DEVELOPMENT APPLICATION ASSESSMENT REPORT

Application Number:	DA2023/0713
----------------------------	-------------

Responsible Officer:	Dean Pattalis
Land to be developed (Address):	Lot 48 DP 6143, 3 Austin Avenue NORTH CURL CURL NSW 2099
Proposed Development:	Alterations and additions to a dwelling house including a swimming pool
Zoning:	Warringah LEP2011 - Land zoned R2 Low Density Residential
Development Permissible:	Yes
Existing Use Rights:	No
Consent Authority:	Northern Beaches Council
Land and Environment Court Action:	No
Owner:	Stephanie Jane Reed
Applicant:	Alex Bryden Architecture

Figure 1: L.O.S percentage approved under CDC2023/0087.

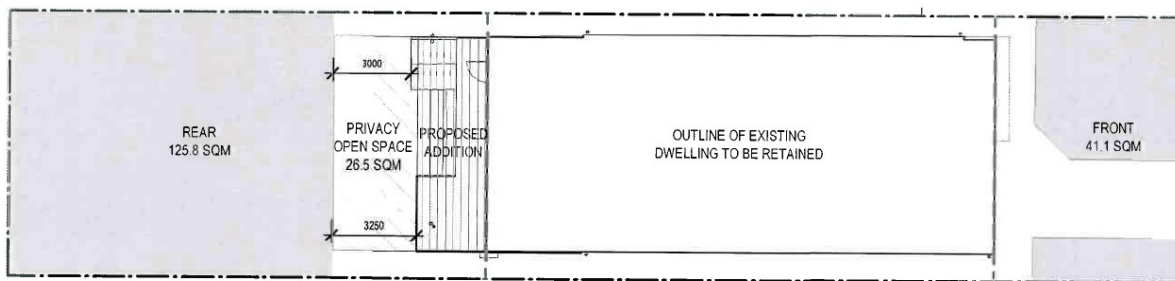
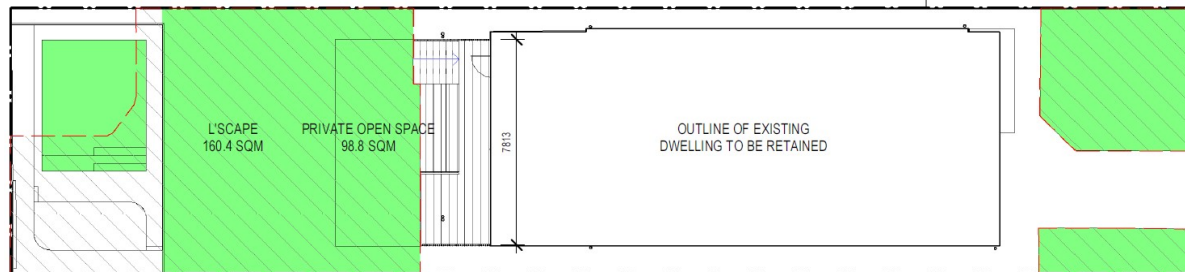
The proposal provides for a total of 35.23% or 160.4m² of landscape open space, a variation of 11.93%, as per the Landscape Open Space diagram provided with the application. (DA010-B)

This is considered a minor and negligible reduction from the existing approved L.O.S for the site, which is 169.9m², as per the approved plans under CDC2023/0087.

As per the proposed drawings, the loss of landscaped area at the rear resulting from the proposed swimming pool is offset by new landscaped area included adjacent to the rear elevation of the dwelling. A condition of consent shall be recommended to ensure the on-site L.O.S arrangement is consistent with the proposed drawings.

Figure 2: L.O.S percentage approved under subject DA.
